**GENOA CHARTER TOWNSHIP
PLANNING COMMISSION PUBLIC HEARING
OCTOBER 9, 2018 (TUESDAY)
6:30 P.M.
AGENDA**

Attention:	Kelly Van Marter, AICP Planning Director and Assistant Township Manager
Subject:	Volunteers of America –Sketch Plan Review #2
Location:	2700 E. Grand River Avenue – south side of E. Grand River, east of Chilson Road
Zoning:	GCD General Commercial District

Re: Volunteers of America Sketch Plan Review #2

LANDSCAPE PLAN

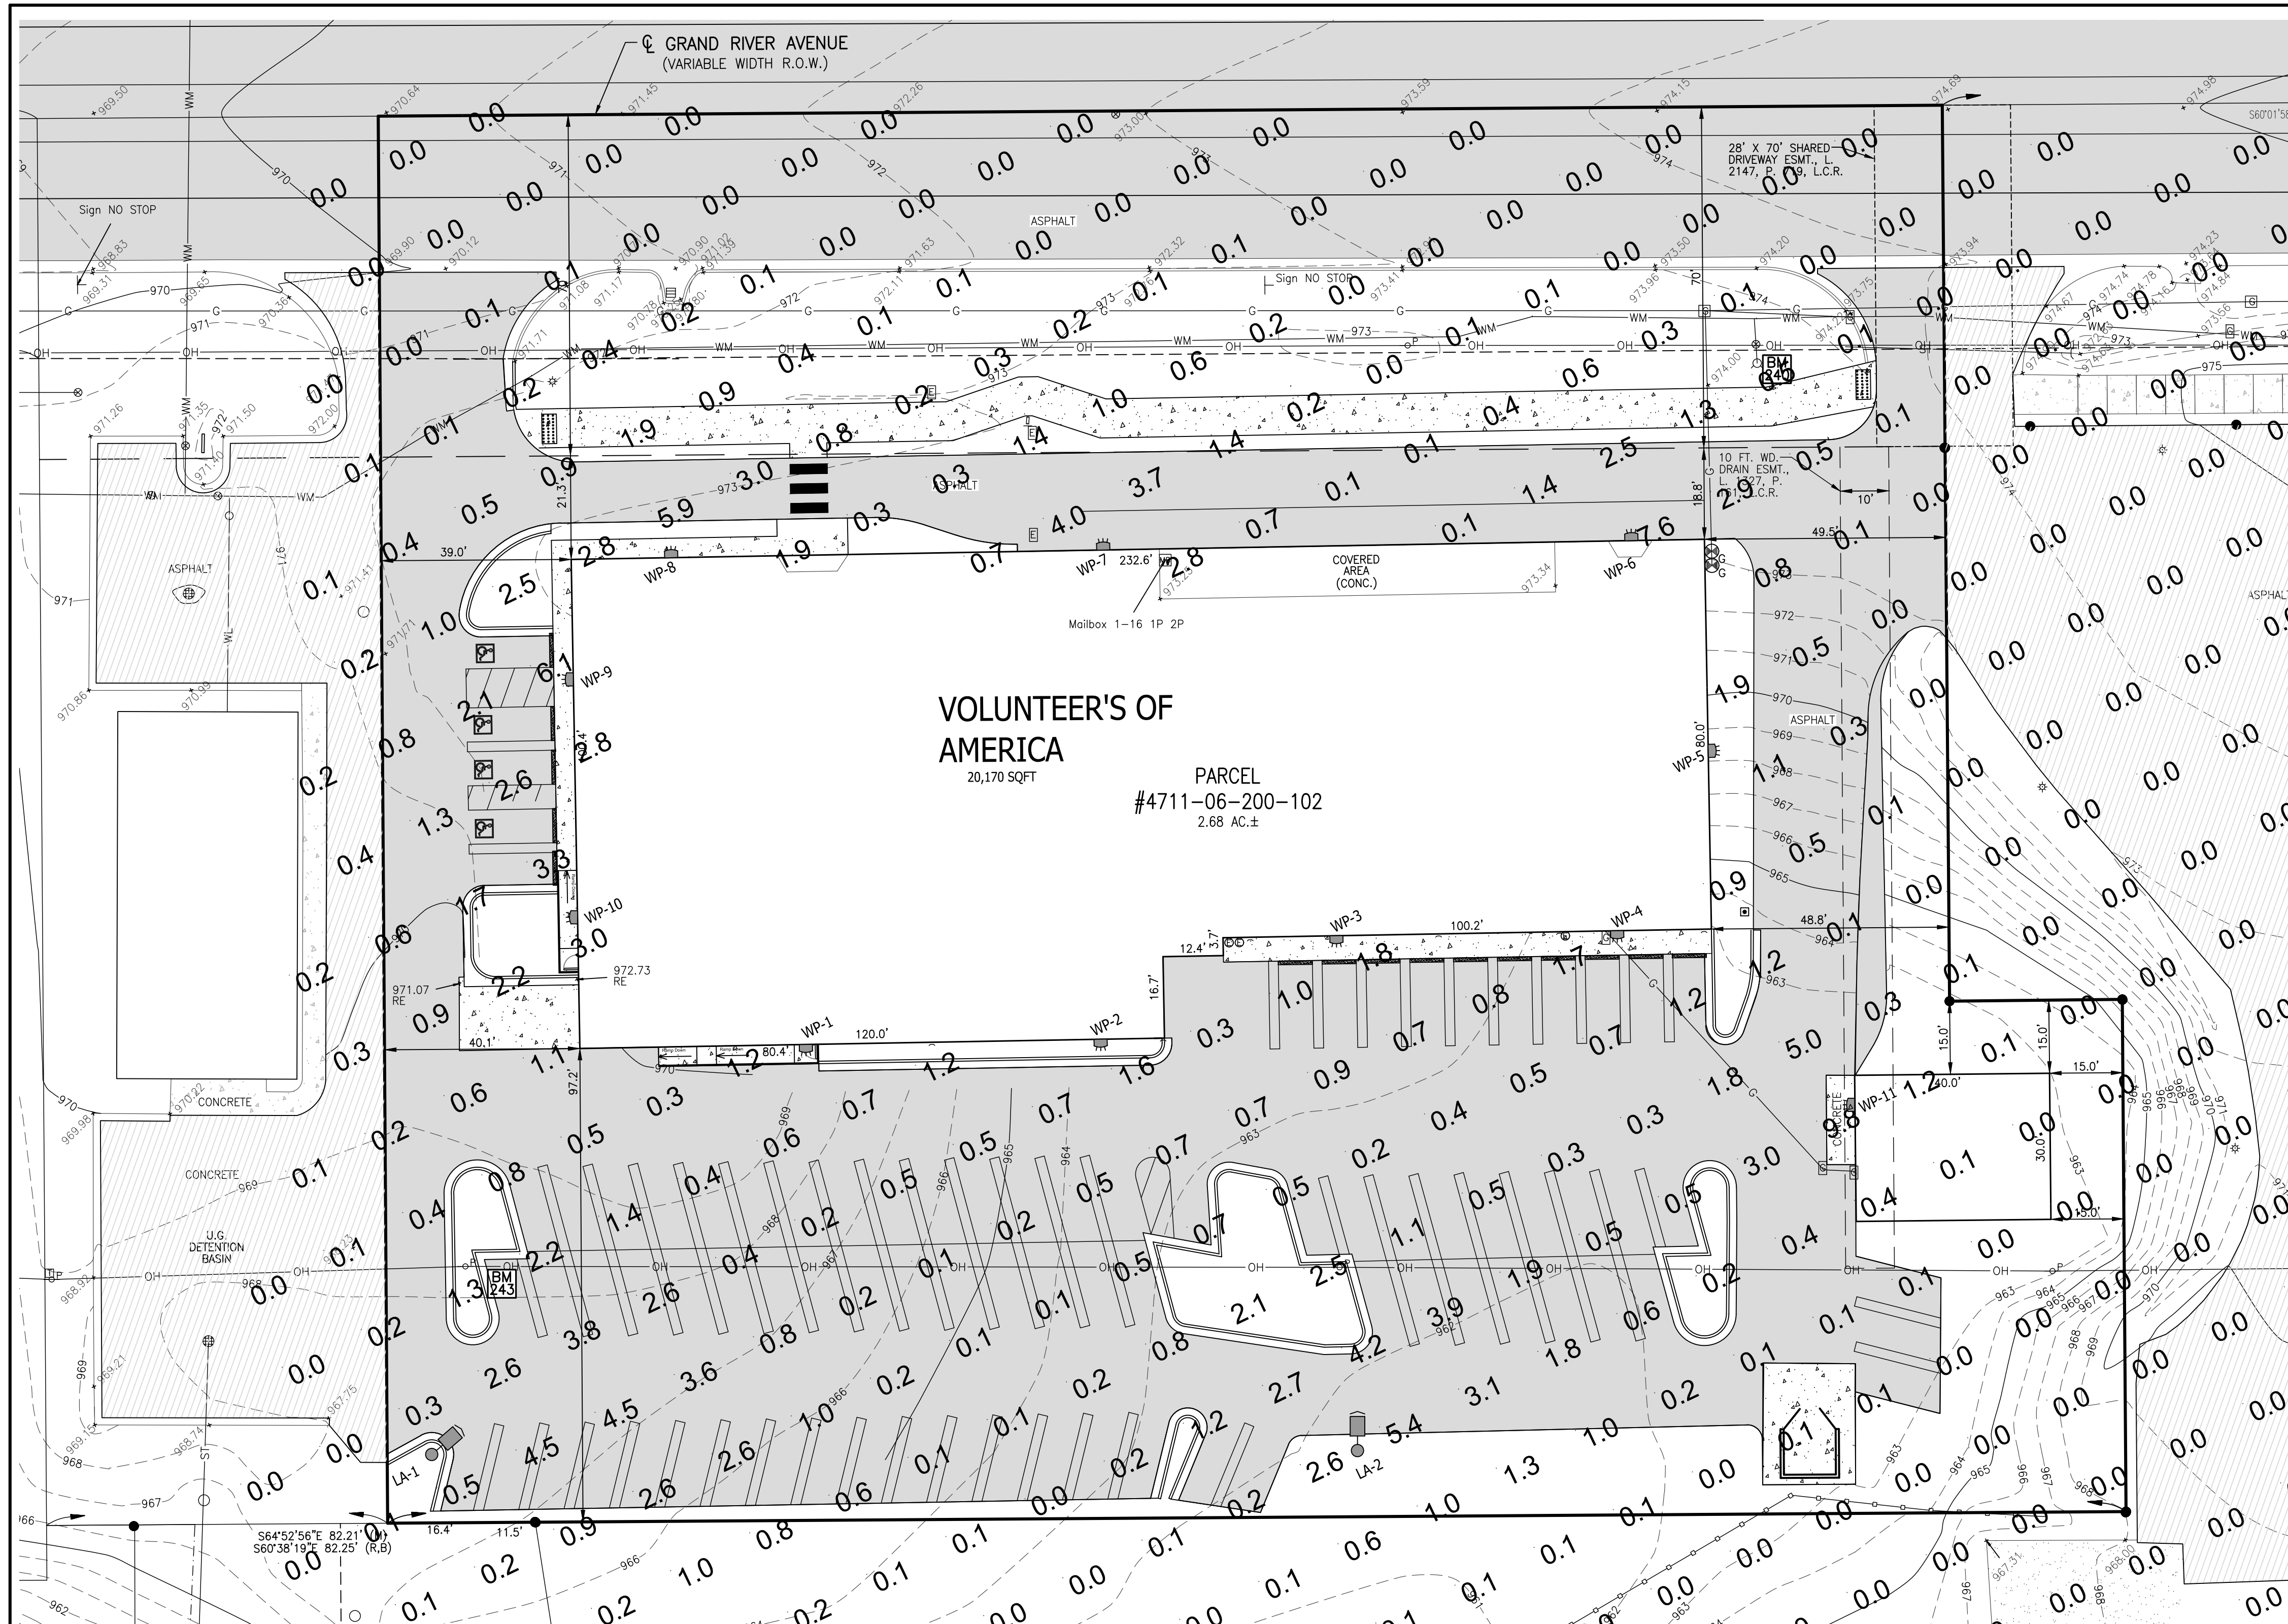
7. Landscaping. The revised landscape plan (Sheet L-1) has been reviewed for compliance with the standards of Section 12.02, as noted in the following table:

The landscape plan and table of plantings are inconsistent in terms of the number of Little Business Daylilies.

PHOTOMETRIC PLAN

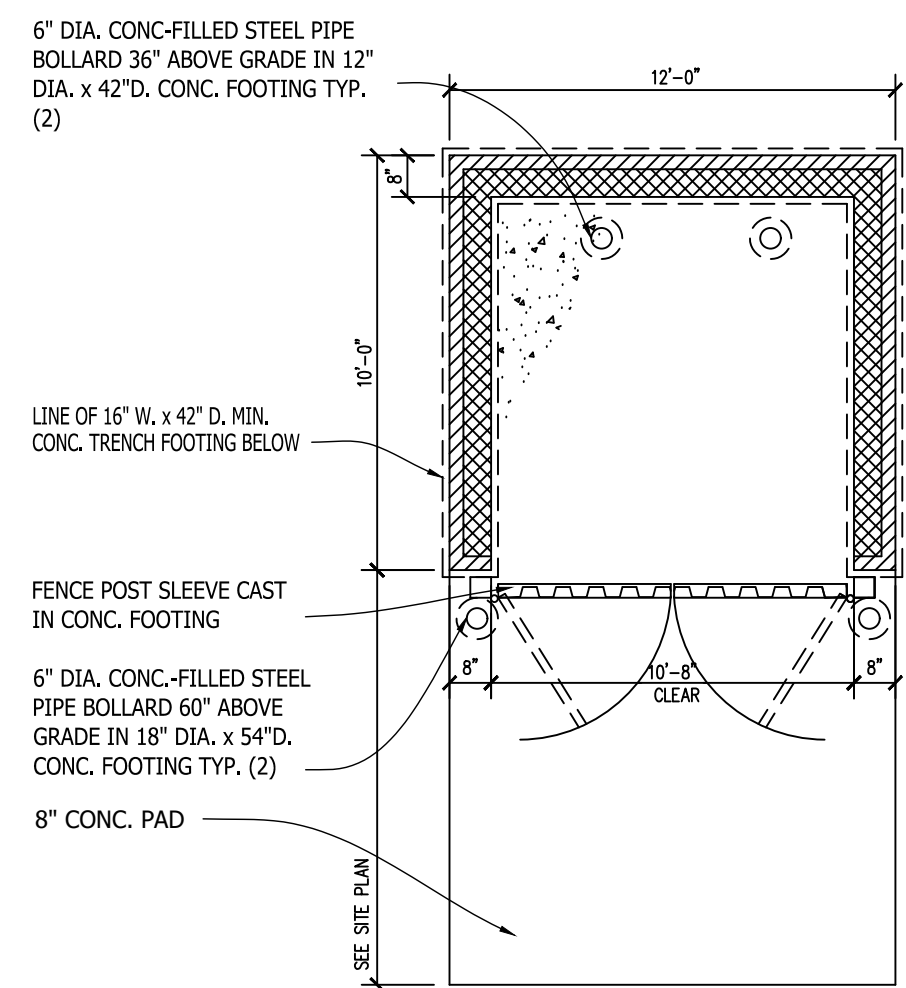
8. Exterior Lighting. The submittal includes a photometric plan and fixture details proposing the use of 11 wall mounted fixtures and 2 parking lot light poles.

The photometric plan complies with Ordinance requirements and the newly proposed fixtures are downward directed and cut-off, with light shining downward.

Front Elevation

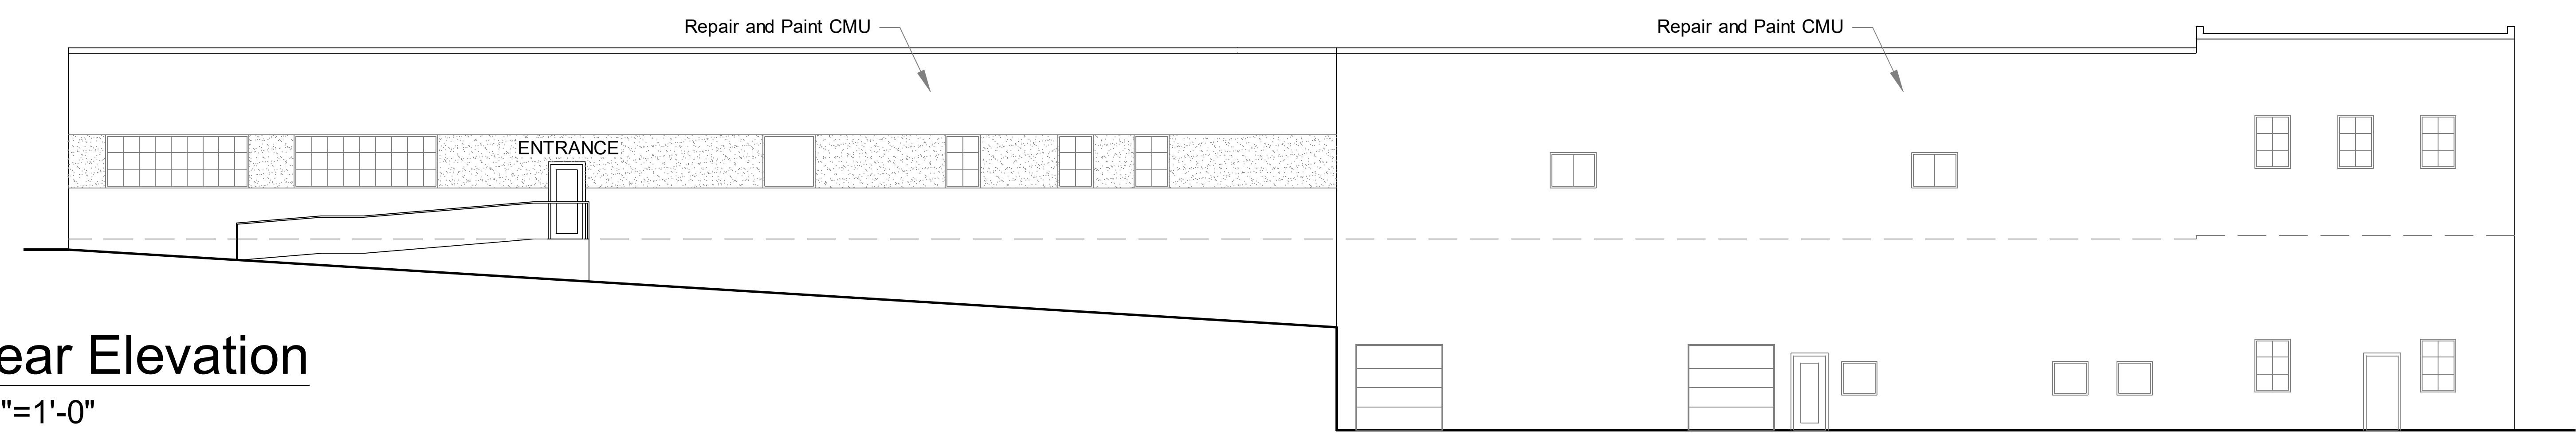
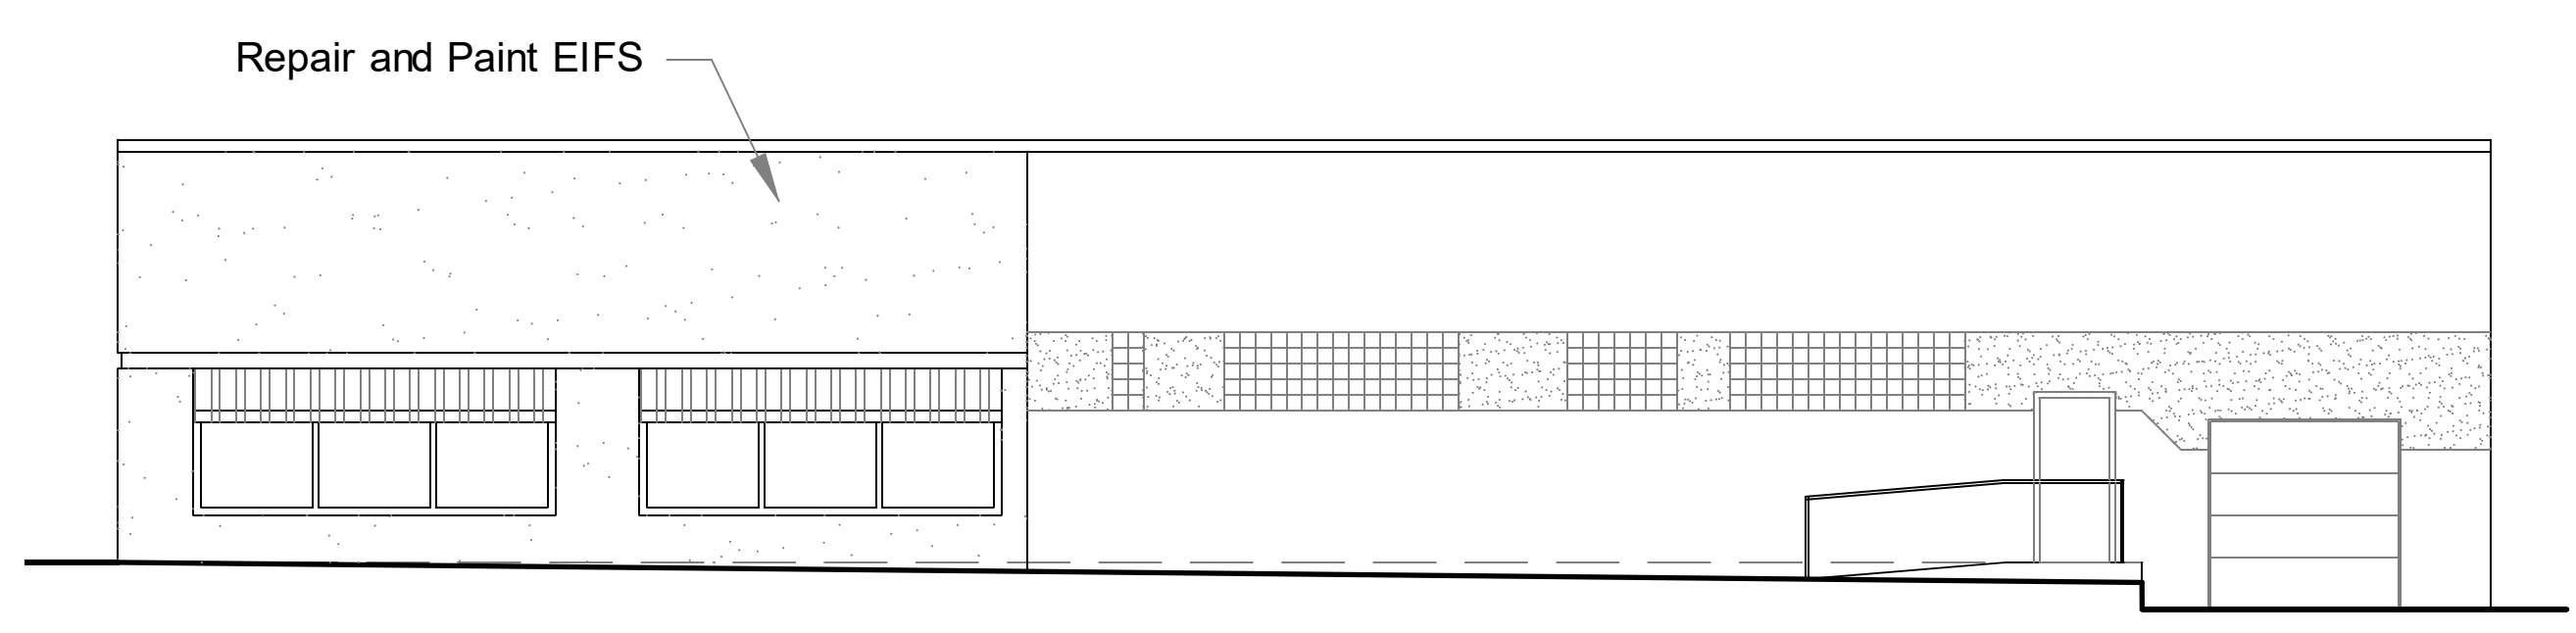
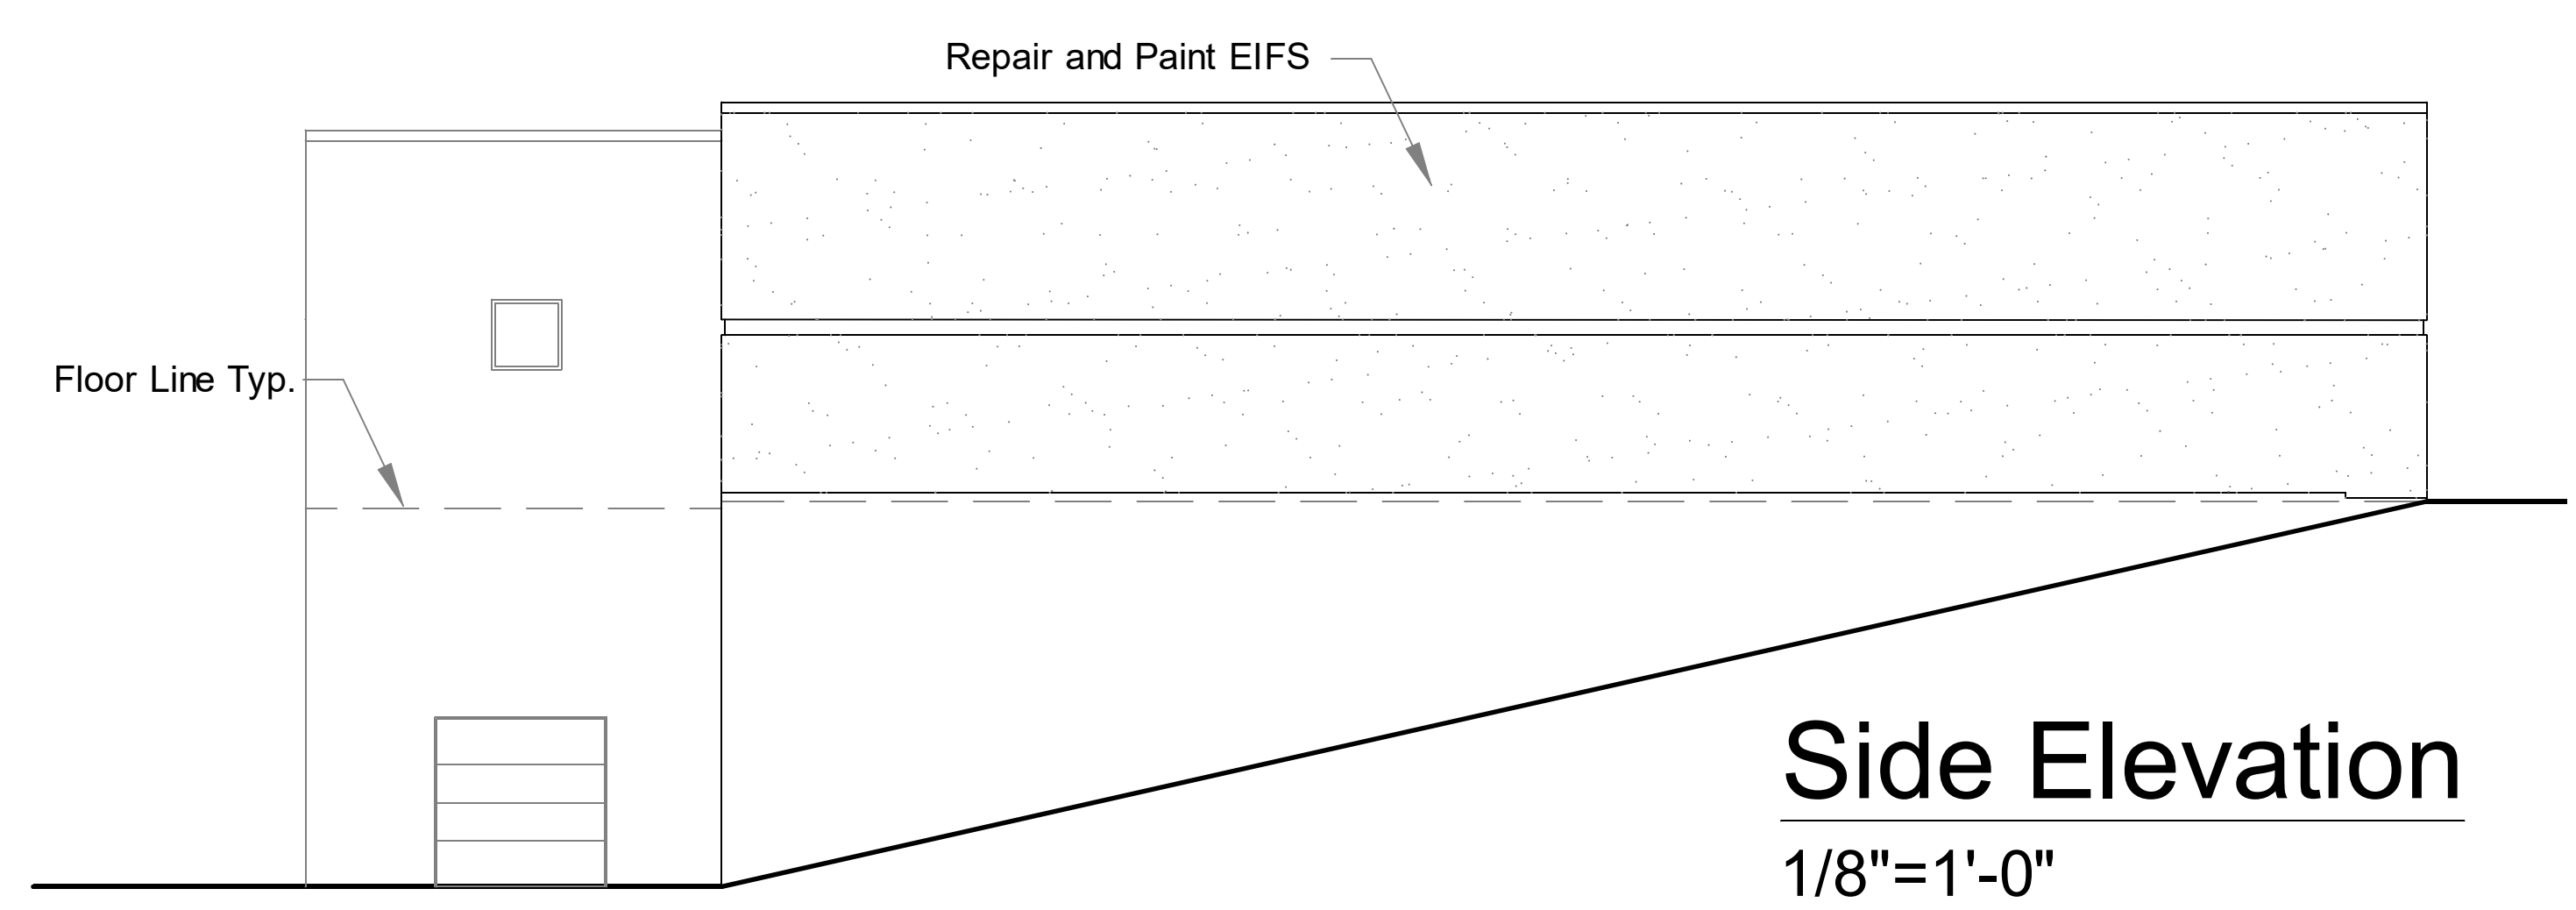
2. **Building Materials and Design.** The primary materials on the existing building are CMU and EIFS. The elevation drawings provided (Sheet A2) note the only changes as repair and painting of the existing building, as well as the installation of new canopies above the windows.
